Bid Addendum 02

Project: CATA Renovation at 511 S Washington Ave, Lansing, MI 48933

Project No: 75820023

GENERAL NOTES

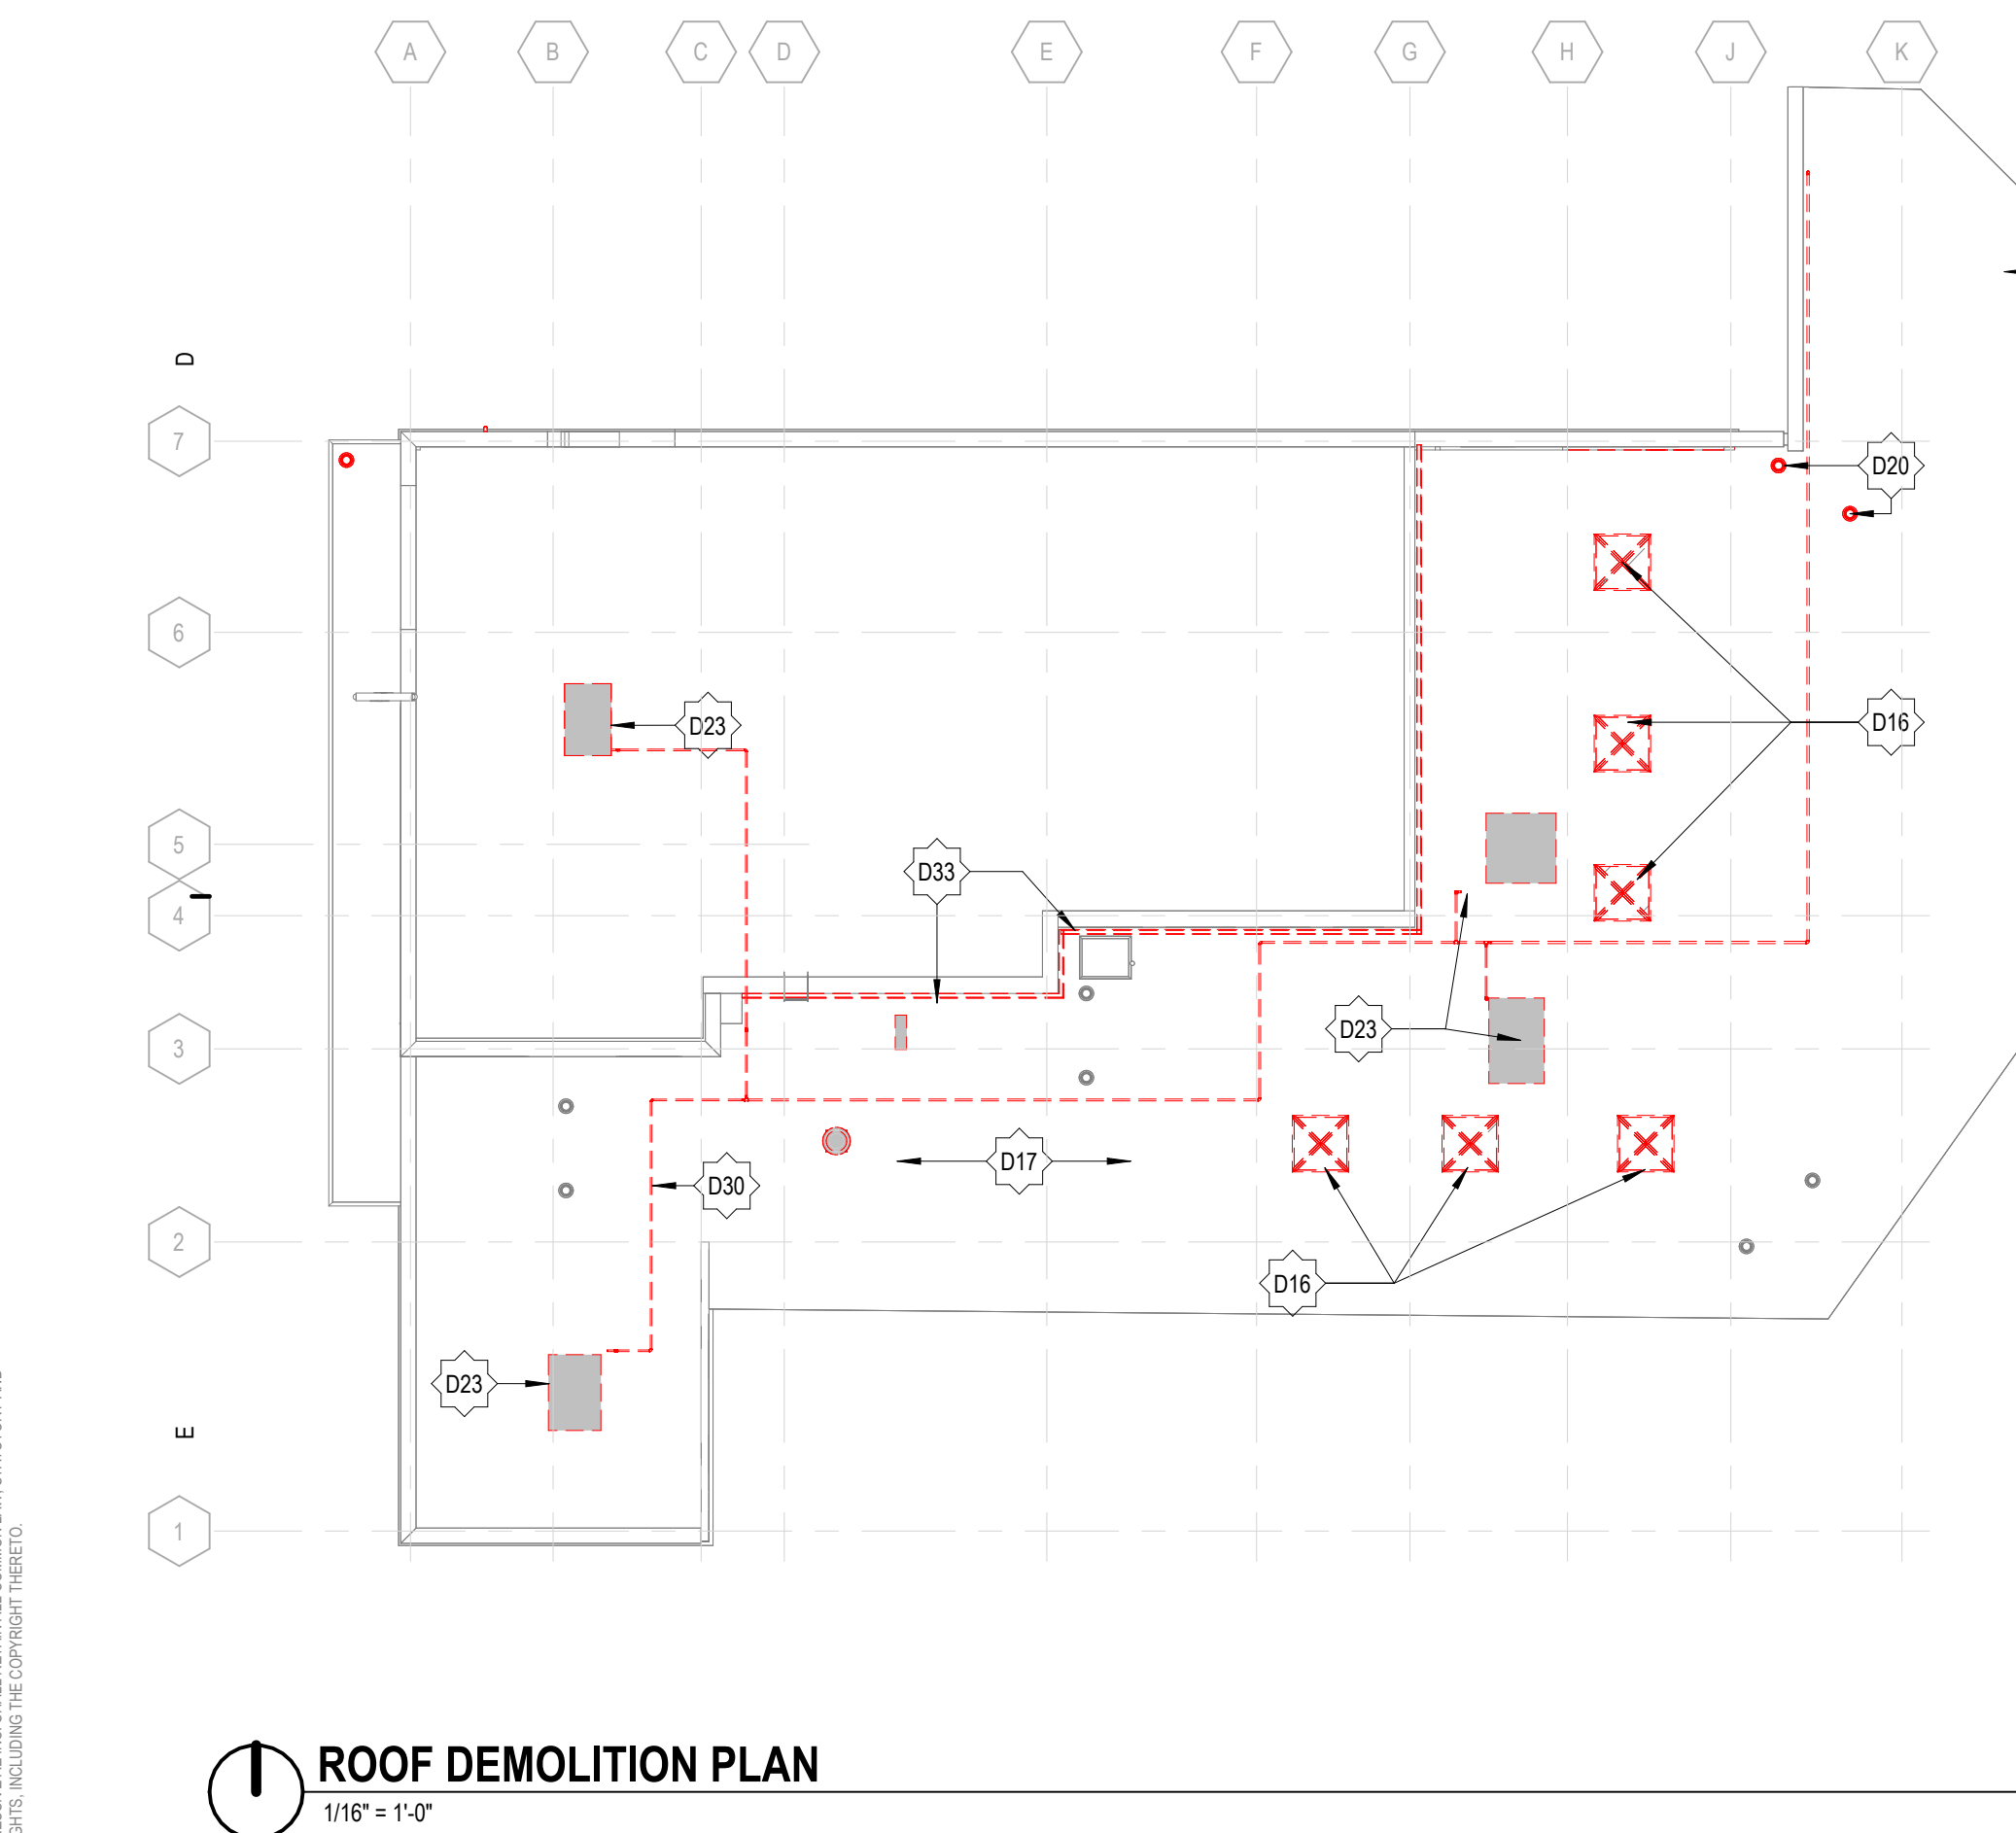
- 1. **Drawing AD101** (Reissued): Add basement demo floor plan to show doors being demolished in basement.
- 2. **Drawing A101** (Reissued): Update basement floor plan doors to show correctly as new with tags. Remove Keynote A18 "REPLACE ALL OPENINGS WITH HOLLOW METAL DOORS AND FRAMES. PROVIDE NEW DOOR HARDWARE."
- 3. **Drawing A104** (Reissued): Update roof plan to add ¼" slope to upper roof for positive drainage required.
- 4. **Drawing A601** (Reissued):
 - a. Update Door Schedule to include basement doors.
 - b. Update door hardware and comments information.
 - c. Update aluminum doors 119A, 119B, and 105A from 4" head to 7'-2" door with standard head to fit masonry opening.
- 5. **Drawing A602** (New Issue): Add Door Hardware Schedule sheet.

ROOF POWER PLAN
1/8" = 1'-0"

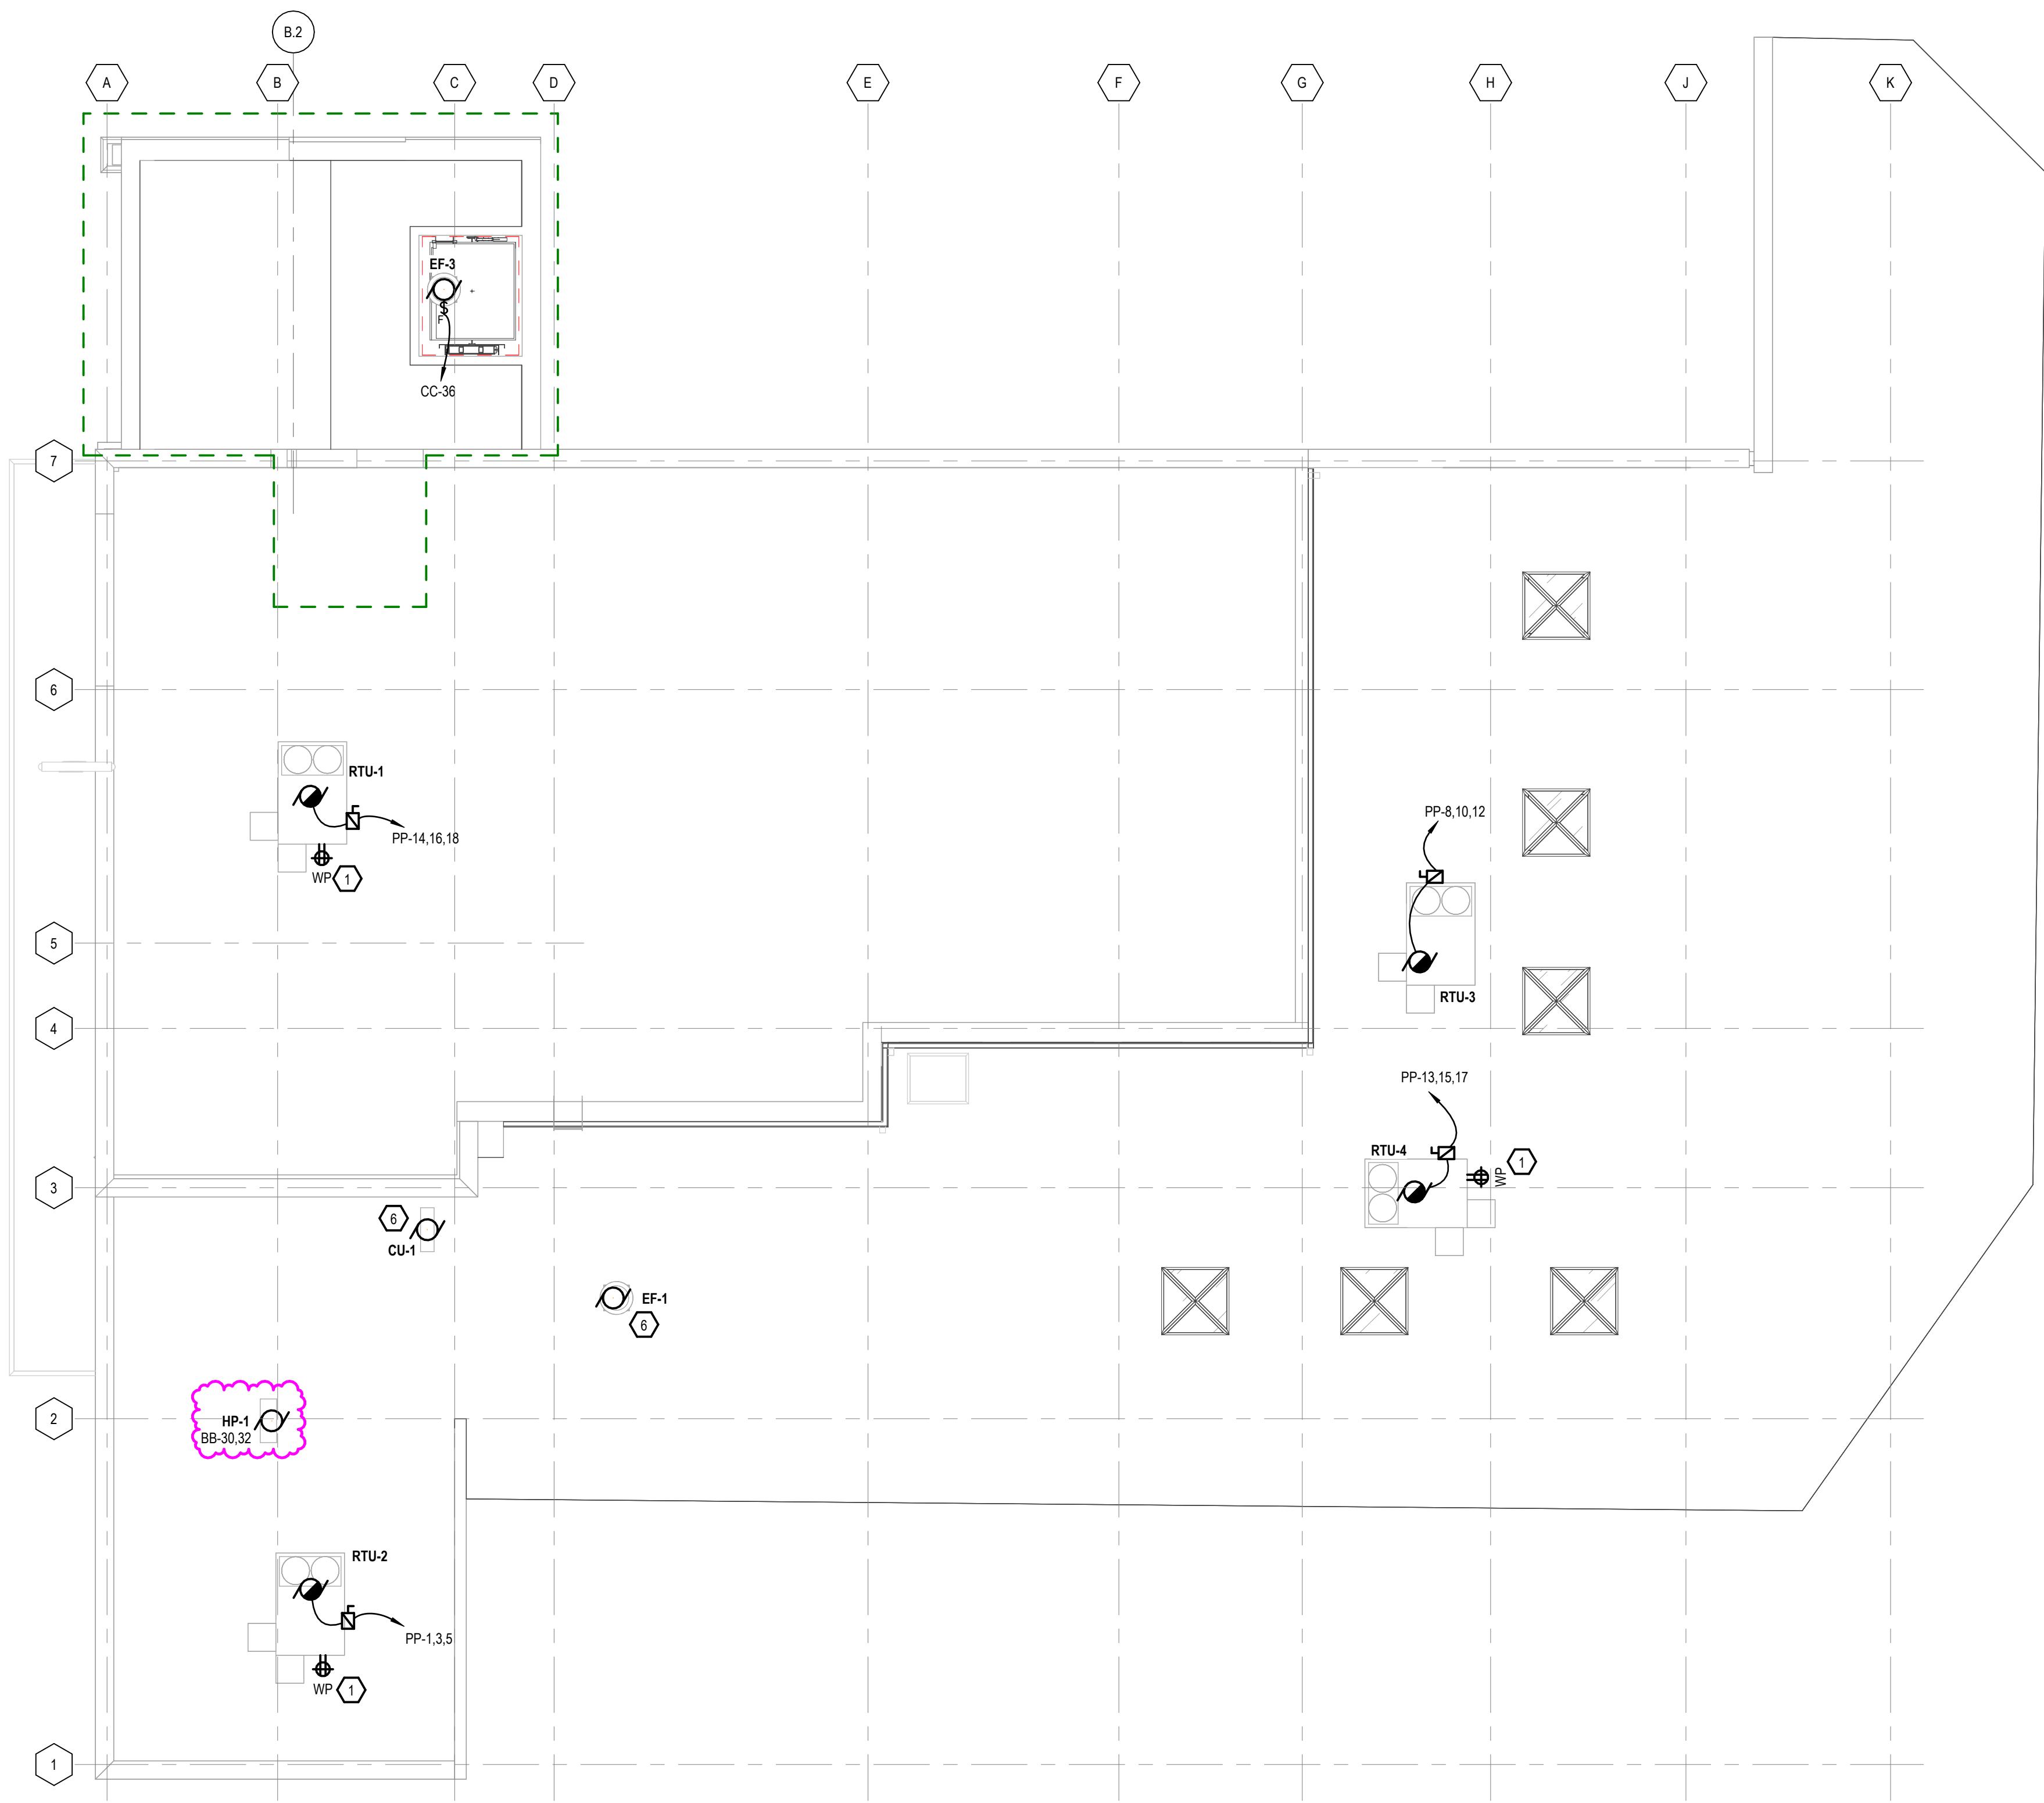
1. **Drawing EP103** (Reissued): Update HP-1 circuit information.
2. **Drawing EL102** (Reissued): Update light fixture in Storage 208.
3. **Drawing E601** (Reissued): Update HP-1 circuit information.
4. **Drawing E602** (Reissued): Update HP-1 circuit information.
